Final Environmental Impact Statement
FutureGen 2.0 Project
Meredosia, Illinois (Morgan County)

DOE/EIS-0460
October 2013

APPENDIX I1
SUMMARY OF PUBLIC HEARING AND COMMENT PERIOD

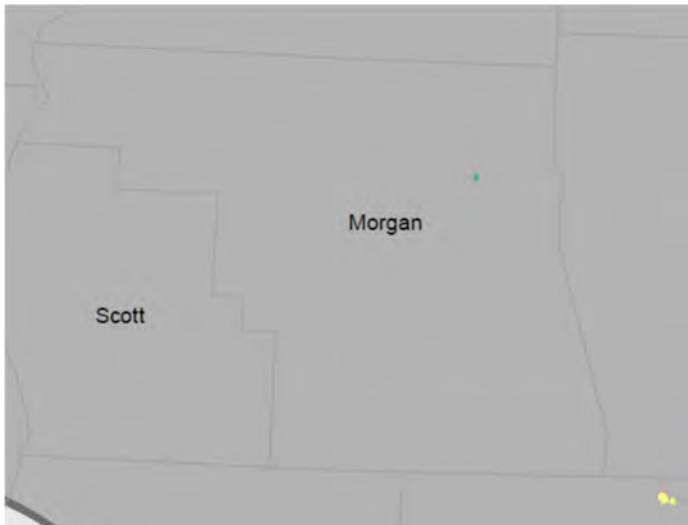
The December 2005 map prepared by the Midwest Geologic Sequestration Consortium entitled "CO₂ Storage Potential for the Mt. Simon and St. Peter Sandstones in the Illinois Basin" indicates areas of idea locations of CO₂ storage. (Note: This map is no longer available on line.) County lines are also on the map and Morgan County is NOT one of the ideal areas for CO₂ storage. I believe the green spot indicates 10-25 million tons of CO₂ potential. Trying to scale this MGSC map to Beacon Schneider puts the

FutureGen 2.0 Project is within 5 miles of this green dot in Section 15 N 9 West. (I attempted to scale green dot location and have it 7.44 miles south of the Morgan County northern county line and 5 miles west of the Morgan County eastern county line in sections 2,3,10, and 11 of township 15 N and range 9 West in Morgan County. **Note: I am awaiting actual location from Sally Greensburg of the IGS/MGSC.**) Given that this map was printed in 2005, it seems that Morgan County area has a potential BUT only for 10 to 25 million tons of CO₂ such that the initial 30 year project forecast exceeded the capacity of the storage area. A FutureGen 2.0 20

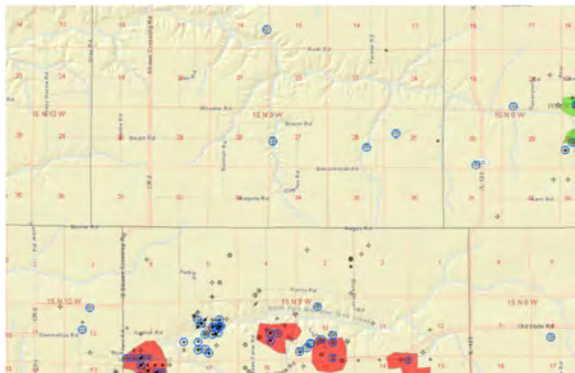
<p>There is this map from the ISGS:</p>	
<p>DOE/EIS-0460D Additional Comments Page 14 of 26</p>

From the Illinois State Geological Survey Prairie Research Institute there are many more wells indicated than shown in Figure 3.4-4. The red areas indicate gas fields south of the CO₂ Storage Area. Each well may indicate a potential source for CO₂ leakage. These are identified in the EIS.

The data represented in Figure 3.4-4 of the Draft EIS are based on data exported from the Illinois State Geological Survey Oil and Gas Resources Internet Map Services and only include data for wells located within the UIC survey area. The UIC survey area is a 5- by 5-mile square area that was outlined to ensure that all wells that could exist within the maximum CO₂ plume boundary would not intersect the Mt. Simon Formation. The only well within this area that penetrates the Eau Claire and Mt. Simon Formations is the stratigraphic well that was drilled by the Alliance in 2011, and was specifically constructed to be resistant to the acidity of the CO₂ plume. The red field in the Illinois State Geological Survey Oil and Gas Resources map is the Prentice field, which is described on page 3.4-9 of the Draft EIS. It contains 25 oil and gas wells, at depths up to 350 feet bgs. There are no oil or gas fields within the UIC survey area; therefore, they are not present in Figure 3.4-4.

Section 3.5, Groundwater, of the Final EIS addresses the groundwater wells and major sand and gravel aquifers within the UIC survey area. Figure 3.5-1 identifies the locations of shallow groundwater aquifers for the FutureGen 2.0 Project, and Figure 3.5-2 presents the shallow groundwater wells within the UIC survey area. The injection wells have been designed in accordance with the design standards specified by the Class VI injection well regulations as documented in the UIC permit applications. By using CO₂-resistant cement at the base of the wells, and selecting a site that has no known vertical pathways for CO₂ migration (e.g., deep wells, faults), the potential for impacts to the shallow USDWs from CO₂ injection would be negligible.
